Meeting: 6/16/2022
Applicant: Brian Pittman Johnson Architecture, Inc
Owner: Knollwood Historic Preservation, LLC

Location: 150 Major Reynolds Place **Parcel ID** 121 A A 02807
District: Knollwood Individual H Landmark
Zoning: C-G (General Commercial)
Description: Neoclassical, c.1851 with modifications dating to 1890s and 1930s
See attached designation report and design guidelines for architectural description of house.

Comprehensive exterior rehabilitation, new secondary structure, and modifications to site design.

6-B-22-HZ

SHUTTERS: SOUTH ELEVATION ONLY

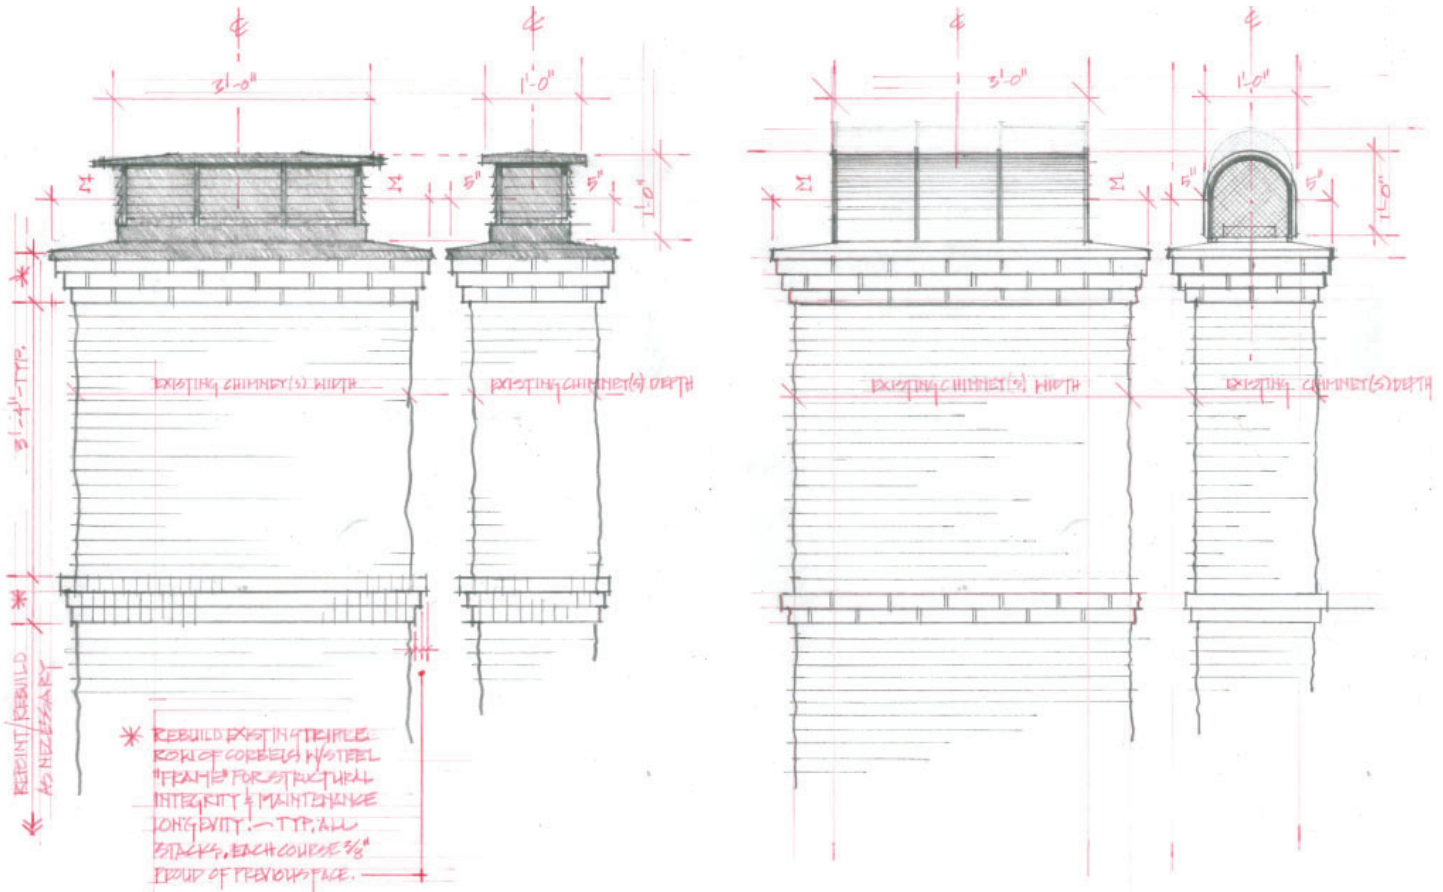
3. The proposed new shutters replace non-original, deteriorated wood louvered shutters on the façade. The application includes a flat-panel design and a smooth-finished, Boral (composite) material for ease of maintenance and longevity of materials. In the opinion of staff, the proposed alternative material can sufficiently mimic the visual qualities of wood if it's smooth-finished and painted. The Commission should discuss the flat panel design and cut-outs versus louvered panels, taking into account SOI Standard 6.

Staff recommends approval of Certificate 6-B-22-HZ; providing for Commission discussion and any additional conditions regarding: the proposed shutter design, the design of the proposed new side elevation door, and the

PROPOSED DORMERS: SOUTH ELEVATION ONLY

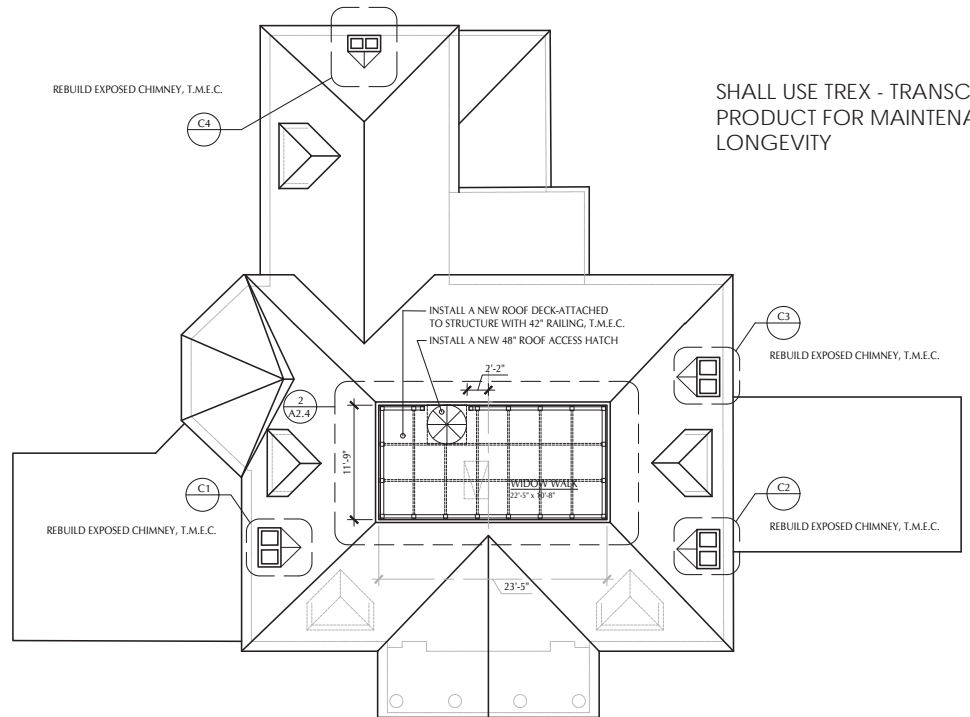
12. The two dormers proposed for the façade roofline are conjectural features which do not meet the design guidelines, as there were never dormers installed on the front roof slope.

- 1) Omission of the proposed front dormers;
- 2) All brick masonry repair and paint removal to meet standards of NPS Preservation Brief 2;
- 3) Meeting all relevant standards of the City zoning code for off-street parking and landscaping;
- 4) Final site plan to meet City Engineering standards, with minor revisions to be approved by staff
- 5) and providing final details on carriage house windows and doors to staff for approval.

MAINTENANCE MEZZANINE

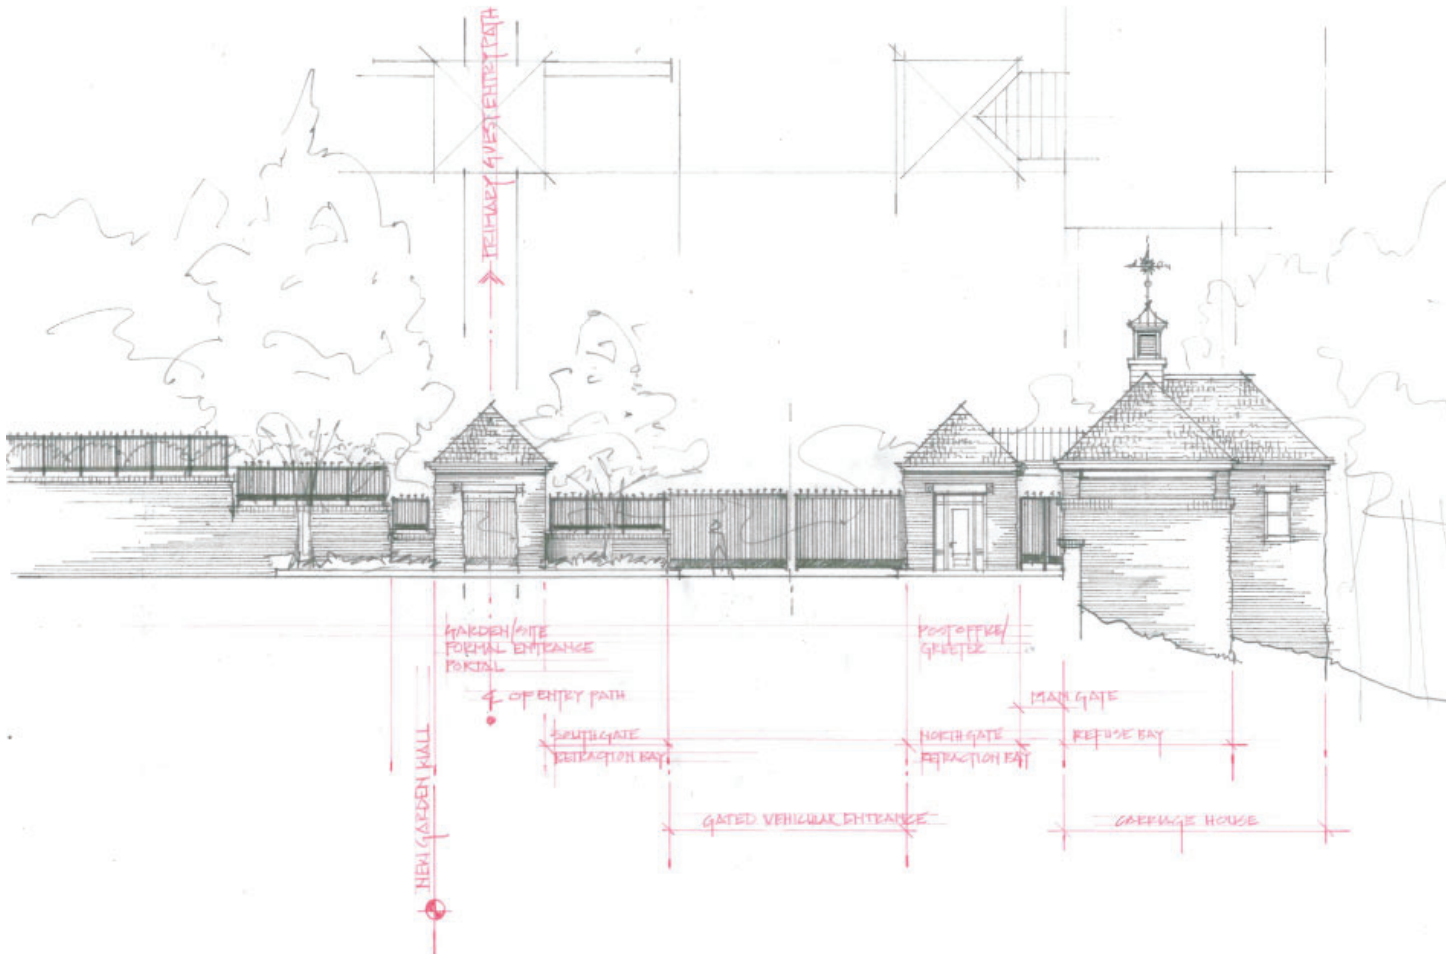
11. The proposed roofline balustrade for the "maintenance mezzanine" lacks a historic precedent from this house. While an iron railing is thin in profile and visually modest in design, the upper deck would be visible from the public right-of-way. The Commission should discuss the visual impact of the iron railing and if it meets SOI Standard 3.

CARRIAGE HOUSE - EAST ELEVATION: FACING ENTRY DRIVE

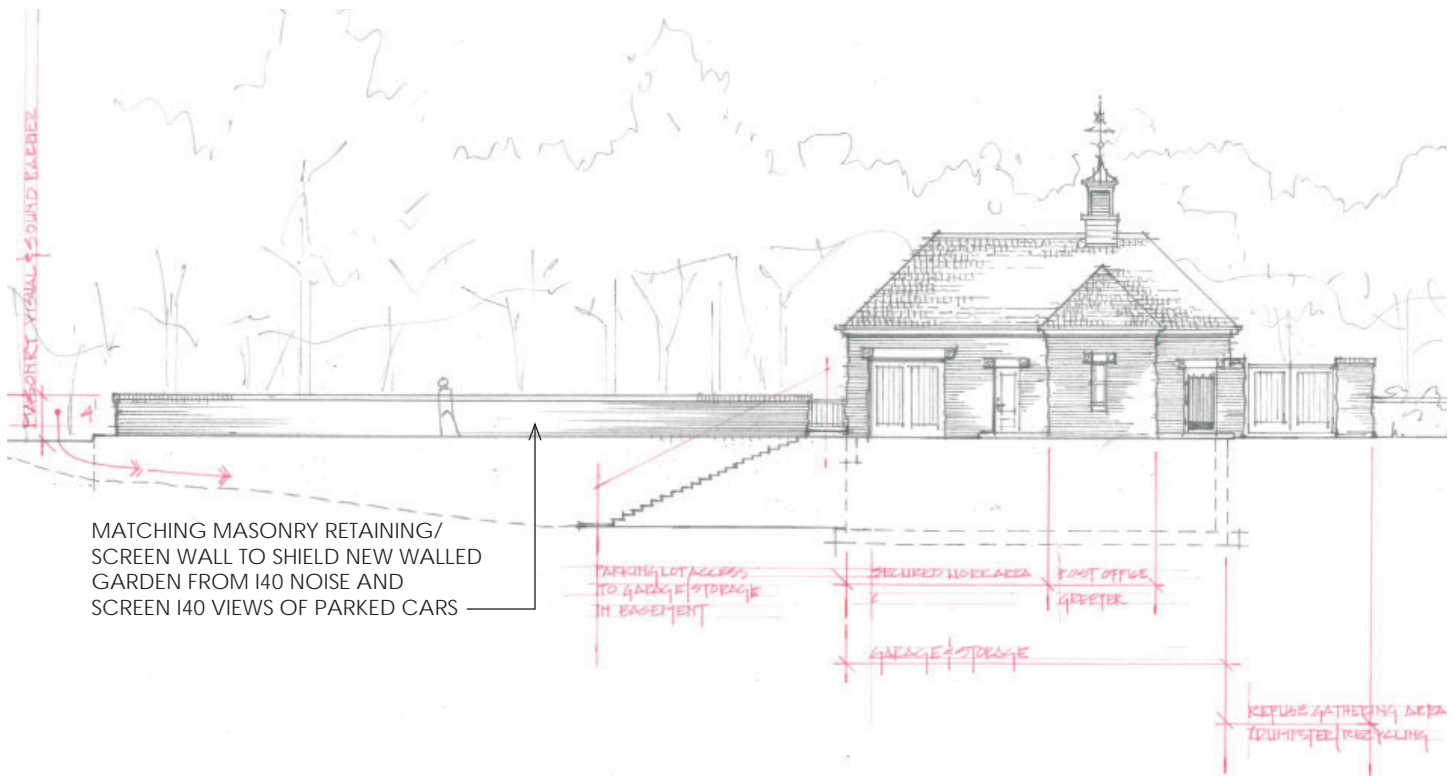
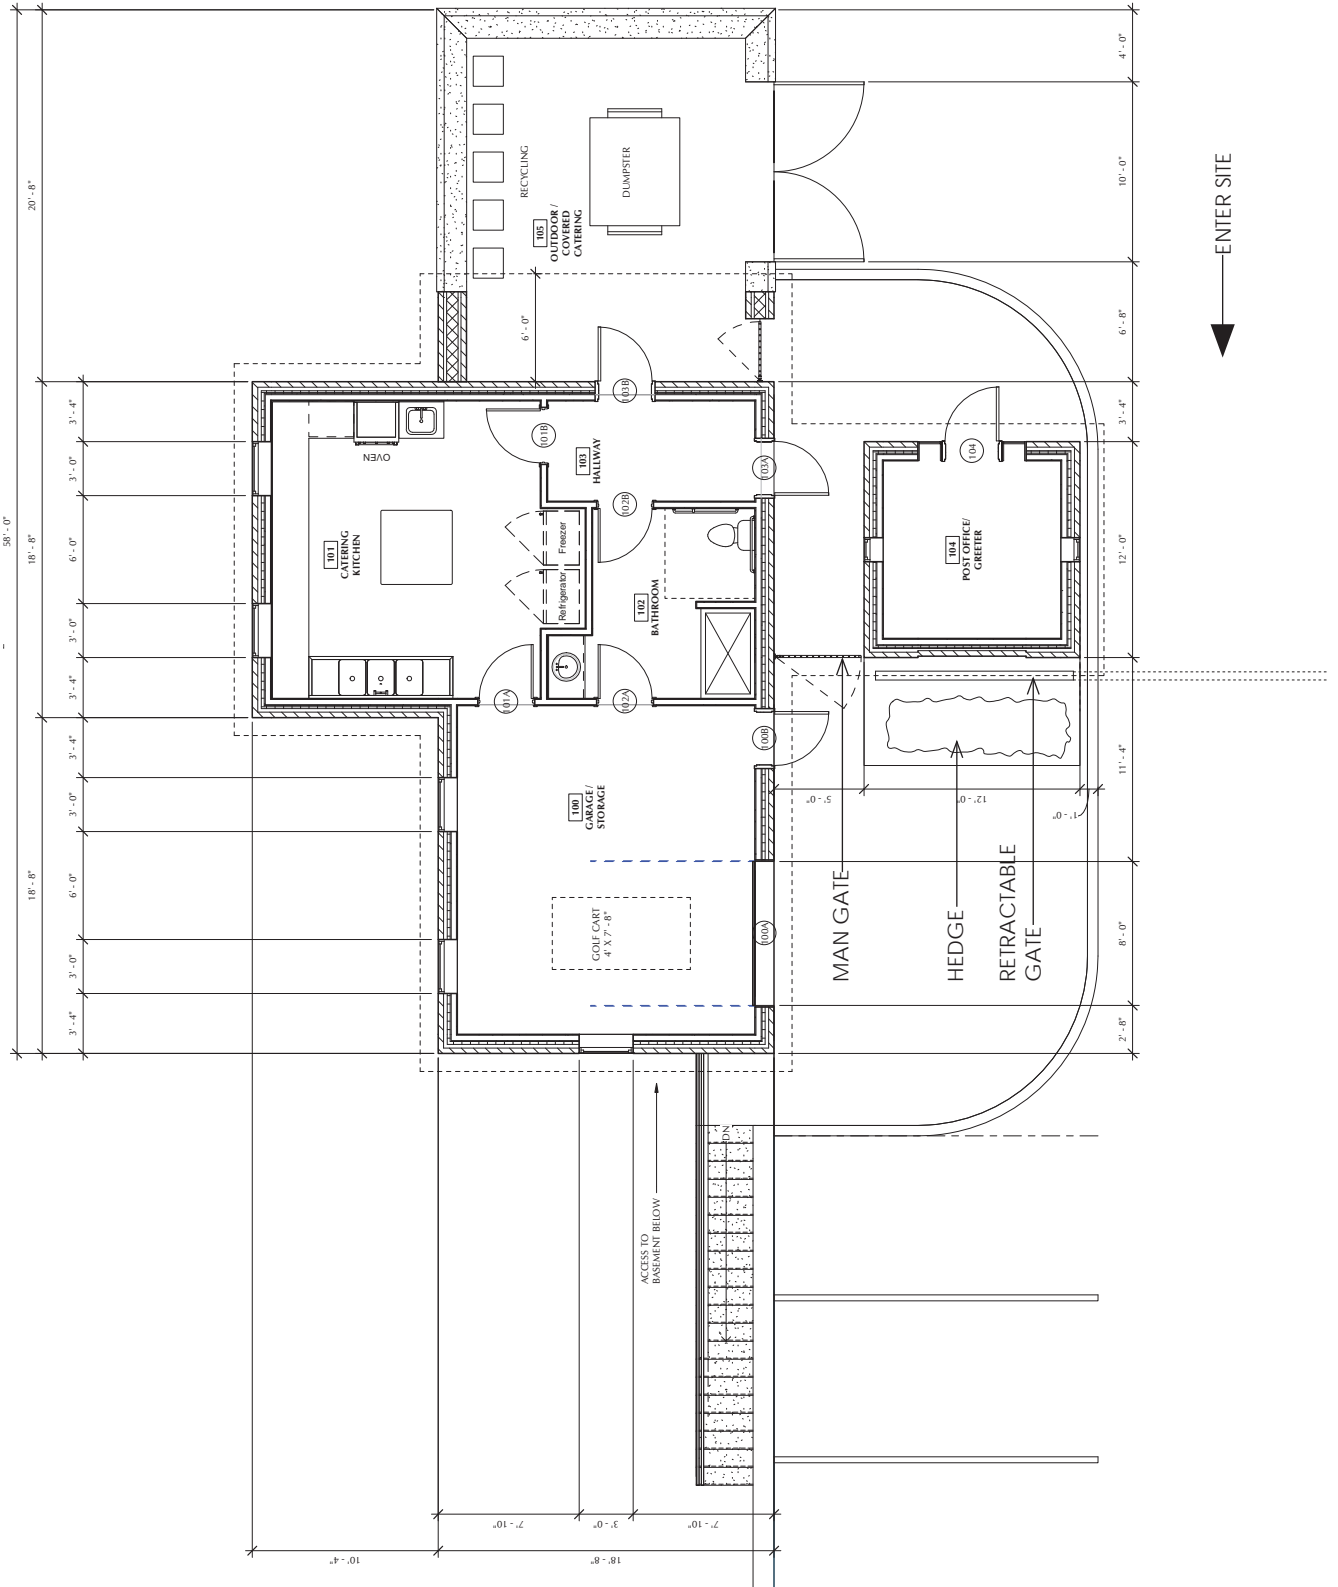
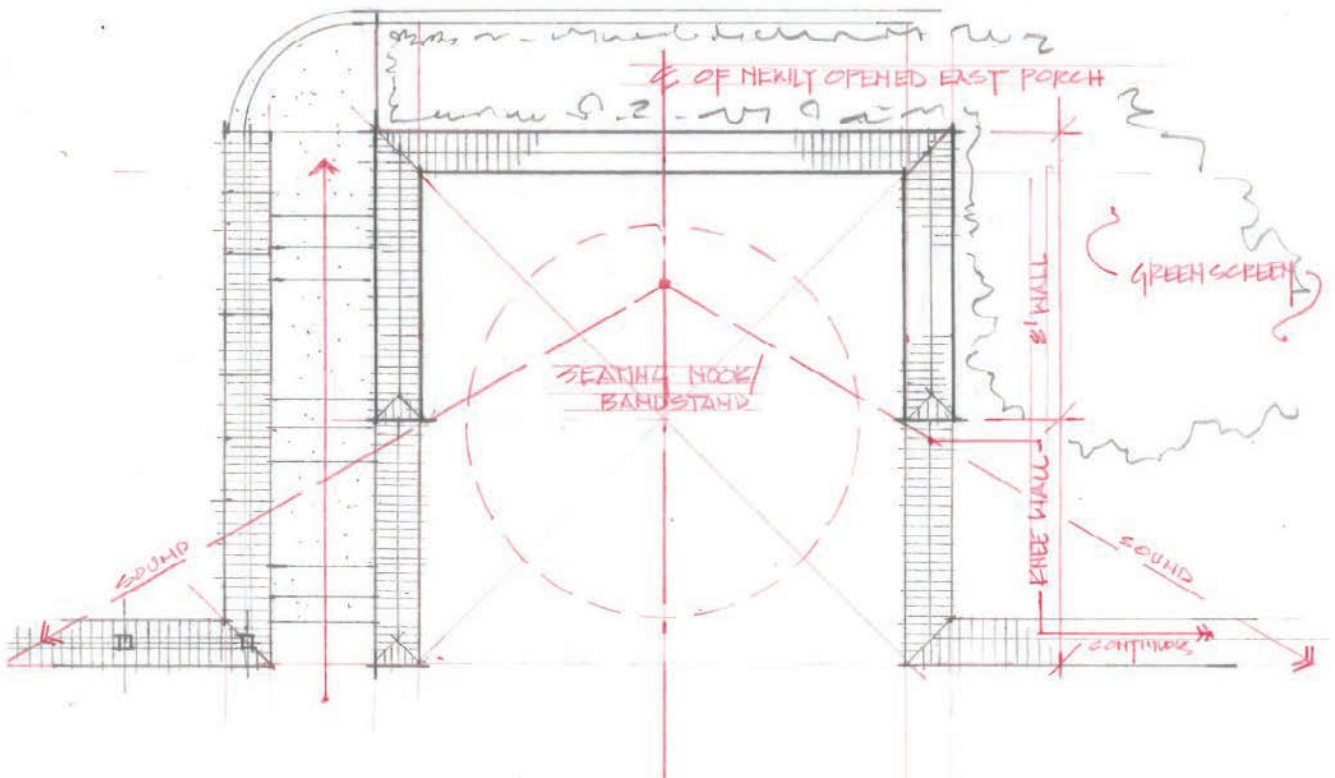
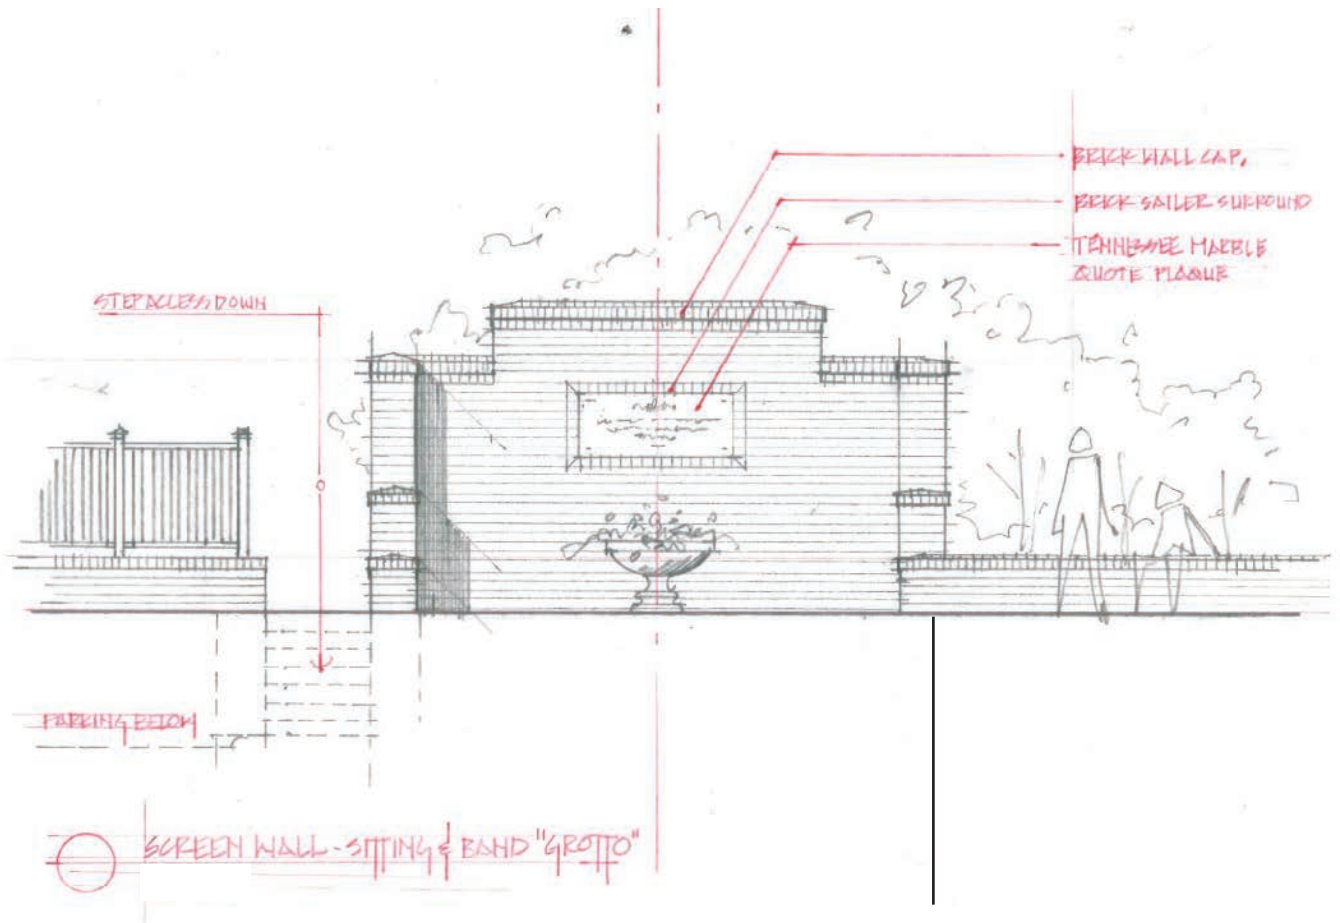
13. The proposed carriage house meets the Knollwood Design Guidelines for placement, which encourage any new buildings built on the site maintain the visual connection between Knollwood and Kingston Pike, and be constructed to the rear of the house when possible to "frame the house and provide background texture for it." The carriage house will locate utilities and service functions outside of the primary house, allowing the main house to serve a function closer to its original use.

14. The proposed carriage house will be clearly secondary to the main house and feature complimentary materials and design. The accompanying fence and gate house are minor in size and will not be visible from the public right-of-way.
